# UNITED STATES PATENT AND TRADEMARK OFFICE

APPLICATION NO.	FILING DATE	FIRST NAMED INVENTOR	ATTORNEY DOCKET NO.	CONFIRMATION NO.
09/462,994	01/14/2000	UDO SCHWALKE	P99.2666	5747
7590 11/14/2003				
SCHIFF HARDIN & WHITE PATENT DEPARTMENT 7100 SEARS TOWER CHICAGO, IL 60606-6473			EXAMINER KEBEDE, BROOK	
			ART UNIT 2823	PAPER NUMBER

<b>Office Action Summary</b>	<b>Application No.</b> 09/462,994	<b>Applicant(s)</b> SCHWALKE ET AL. <i>mu</i>	
	<b>Examiner</b> Brook Kebede	<b>Art Unit</b> 2823

## DETAILED ACTION

**FIG 7**

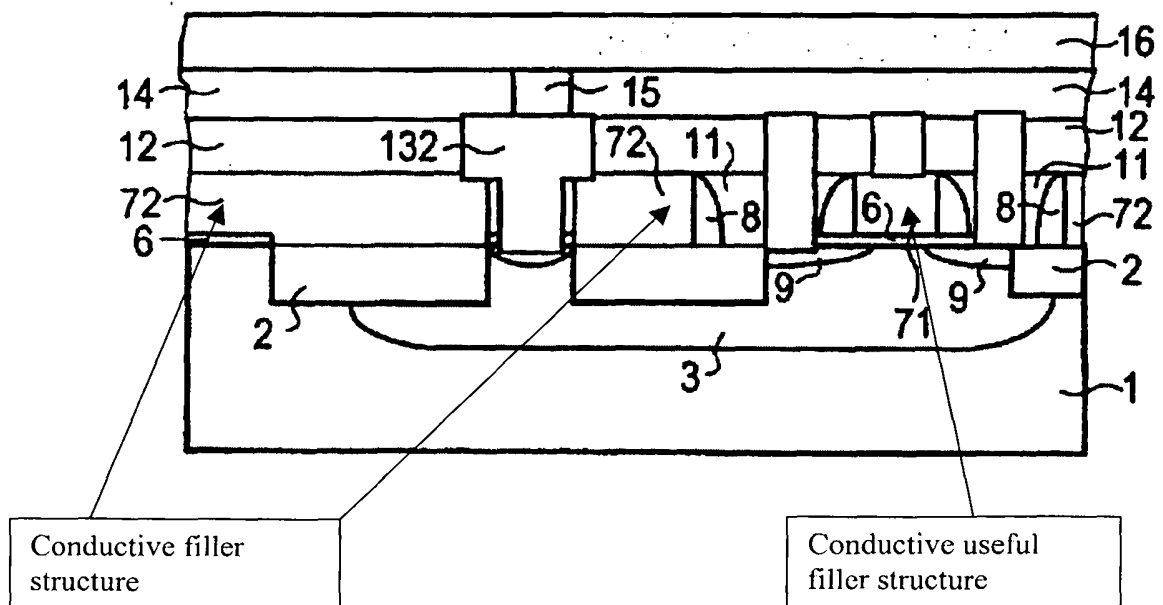
Prior responding applicants' contention that Hirakawa fails to disclose the use of filler structures that perform no circuit-oriented functions, as amended in claim 11, the Examiner respectfully submits the instant application drawing Fig. 7 herein below to show inconsistency between what is being claimed and what is applicants presented to support their argument to show what Hirakawa et al. '508 patent teach or does not teach.

As shown above in Fig. 7, i.e., the instant application drawing, the conductive useful structure **71** formed over the gate oxide film **6**. In the other hand, the conductive filler structure **72** formed on the STI **2** (shallow trench isolation) that is planar with the substrate **1**. As Fig. 7 shows, the conductive filler structure **72** does not have same height as the conductive useful structure **71**. As depicted on Fig. 7, one of ordinary skill in the art will conclude that the height of **72** is not equal to the height of **71**. In contrary applicants assertion, the **height of 72** equals to the **height of 71** plus **height of 6**.

In response to the applicant's argument, the Examiner respectfully submits that such an argument is not commensurate with the scope of the claims, in particular, as stated above. The Examiner respectfully submits the combination of Shimomura et al. '421 and Uehara et al. '902 teach all the claimed limitation. In addition, the Examiner respectfully would like to point out that "conductive filler structure" and "conductive useful structure" has no any special meaning as one of ordinary skill understands in light of the instant application disclosure and Figures 1-7, as particularly shown in Fig. 7 herein above. The "conductive filler structure 72" is a resistor and the "conductive useful structure 71" is a gate electrode. If there is a different interpretation can be made as alleged by applicants, applicants should provide the Office an evidence that conductive

filler structure **72** has different function than form being resistor and conductive useful structure **71** also being gate electrode. What is the “conductive useful structure” mean? What is the “conductive filler structure” mean? Applicants need to clarify this matter because their argument suggest otherwise (see Applicants argument in Pages 10-12) and the whole application may be rejected under 35 U.S.C. 112 first and second Paragraph for lack of enabling disclosure and lack of clarity.
